**Subject:** Catawba Nuclear Station Units 1 and 2; Docket Nos. 50-413, 50-414  
McGuire Nuclear Station Units 1 and 2; Docket Nos. 50-369, 50-370  
Partial Response to Request for Additional Information Regarding the Use of  
Mixed Oxide Lead Fuel Assemblies

**Reference:** NRC Letter dated July 25, 2003, Request for Additional Information Re: Mixed  
Oxide Lead Fuel Assemblies (TAC Nos. MB7863, 7864, 7865, 7866)

Attachment  
Partial Response to NRC Staff Request for  
Additional Information dated July 25, 2003

Figure Q13-1  
Loop Noding Diagram

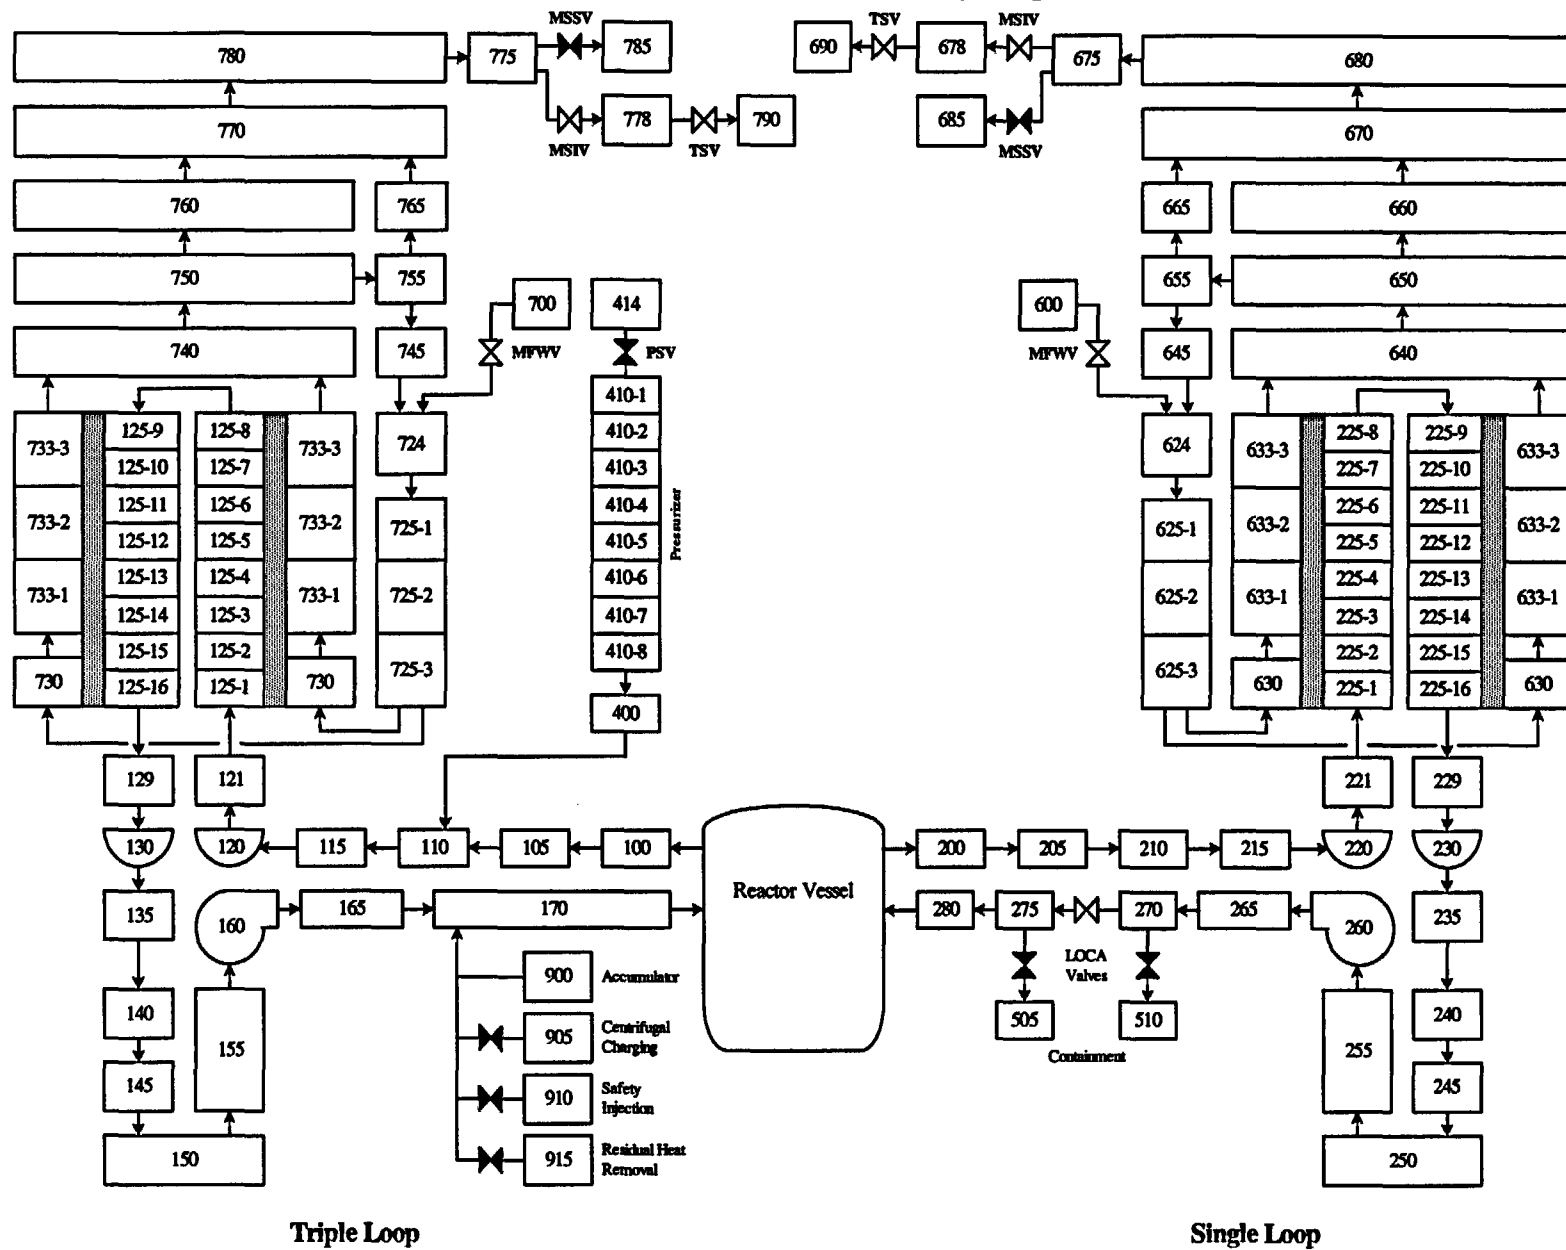
13. To allow the NRC staff to perform confirmatory analysis, please provide both the McGuire and Catawba loss-of-coolant accident (LOCA) input decks for the low enriched uranium (LEU) as well as the MOX fuel rods. Provide the decks in an electronic format, including nodalization diagrams.

Figures Q13-1 and Q13-2 are node diagrams for the decks. Figure Q13-1 shows the loop node arrangement while Figure Q13-2 shows the reactor vessel node arrangement. Figure 3-5 of Attachment 3 to Reference Q13-1 provides some additional detail specific to the core region.

Figure Q14-1  
MOX Fuel Lead Assembly Total Core Peaking Factor

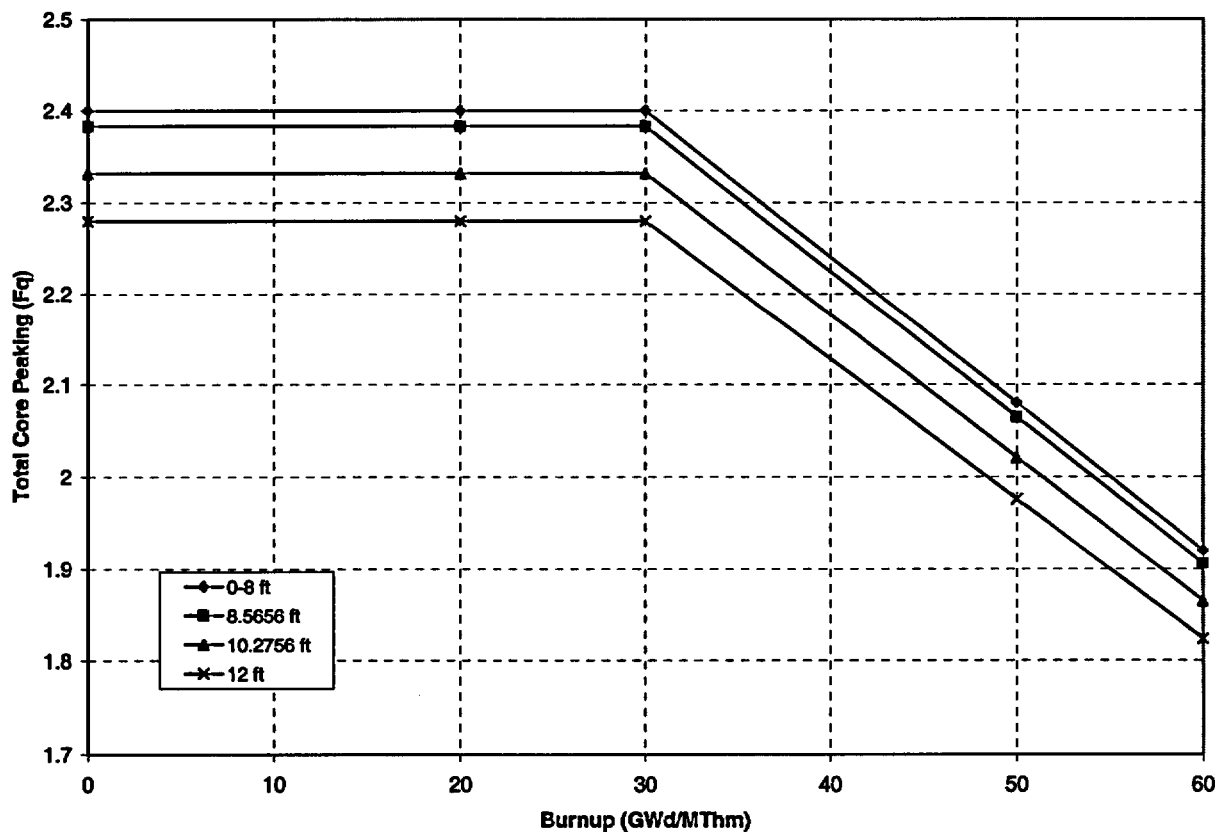
14. Provide the reference to the best estimate LOCA model noted in section 3.7.1.7.

A summary of the sensitivity cases is provided in Table Q14-1. The resulting LOCA peaking requirements for the MOX fuel lead assemblies are shown in Figure Q14-1. These peaking requirements will assure that the MOX fuel will comply with the regulatory limits for LOCA as provided in the response to Reactor System RAI Question 12.

Figure Q18-1  
MOX Fuel and LEU Fuel Colorsets

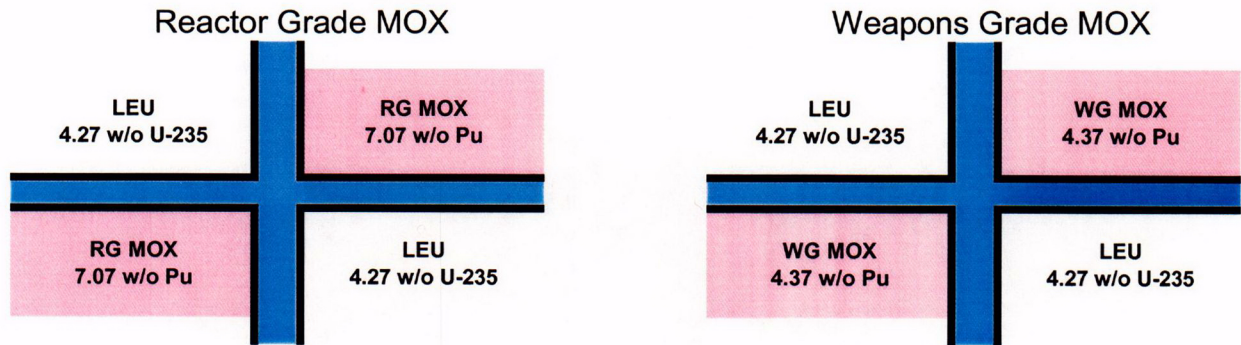
18. In sub-section 3.7.1.1.1, nothing is mentioned about the MOX/LEU interface behavior. Provide a qualitative and quantitative discussion regarding the neutron flux behavior at the interface of the MOX and LEU fuel assemblies.

Duke used the CASMO-4 computer code to model pin cell neutron flux and power at the intersection of four quarter-assembly lattices. These "colorsets" provide detailed two dimensional neutronic calculations that account for interface effects between dissimilar fuel assemblies. MOX fuel assemblies and LEU fuel assemblies of equivalent lifetime reactivity were placed in a checker board arrangement to simulate face adjacent MOX and LEU fuel assemblies (see Figure Q18-1). Two cases were considered – one using MOX fuel with weapons grade (WG) plutonium isotopics, and another using MOX fuel with reactor grade (RG) plutonium isotopics. The lead assemblies will be WG MOX fuel; the RG MOX fuel

Figure Q20-1  
Impact of MOX Fuel Loading and Burnup on  
Effective Delayed Neutron Fraction ( $\beta_{\text{eff}}$ )

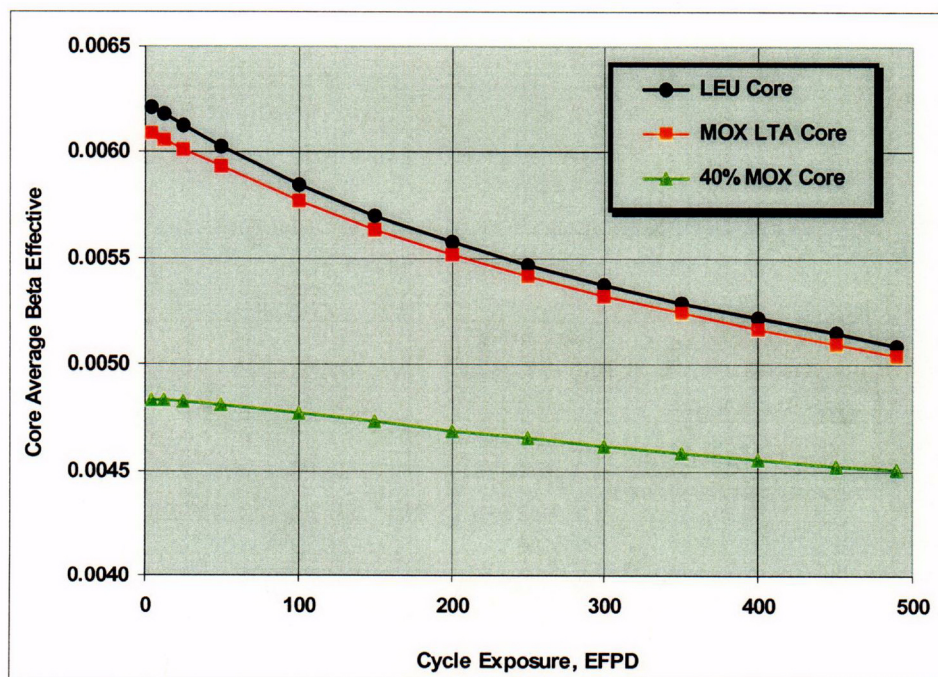
20. Also, in the second paragraph of sub-section 3.7.1.1.1, the change in the delayed neutron fraction is discussed at beginning of life. However, the behavior of the delayed neutron fraction at middle of life and end of life is not addressed. Provide a discussion on the delayed neutron factor change with respect to burnup.

Table Q20-1 and Figure Q20-1 show the variation in core average effective delayed neutron fraction ( $\beta_{eff}$ ) with cycle burnup and MOX fuel loading. The introduction of four MOX fuel lead assemblies results in a minor decrease in beginning of cycle (BOC)  $\beta_{eff}$ . The impact on end of cycle (EOC)  $\beta_{eff}$  is even smaller. The 40% MOX fuel core sees a more significant reduction in  $\beta_{eff}$  at BOC, but the change in  $\beta_{eff}$  with burnup is much smaller than the corresponding change in a core containing all low enriched uranium (LEU). The result is that the 40% MOX fuel core has more uniform kinetics over the cycle.
